5" RANDOM ORBITAL SANDER

Model BO5020 5" RANDOM ORBITAL SANDER V.S. Model BO5021

SERVICE CHANGES

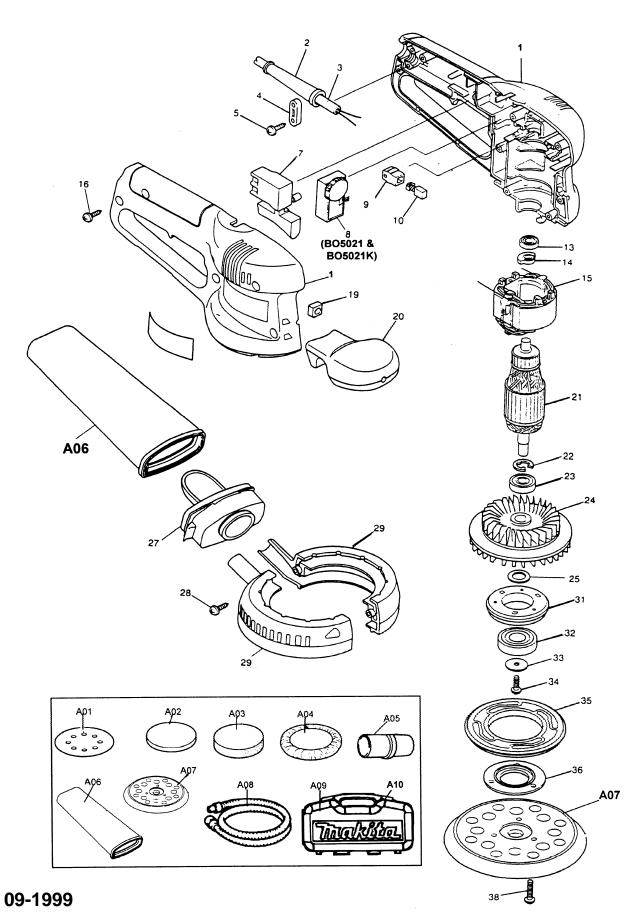
1. Change on Ball Bearing.

Item No.	Description	Type 1	Type 2 211236-8	
32	Ball Bearing 6002DDW	211227-9

To Prevent excess rotation when the Sander is NO LOAD, please change to Type 2 Ball Bearing which is packed with a thinner grease. There is no visual difference between Type 1 & Type 2 Ball Bearings.

Above parts are completely interchangeable
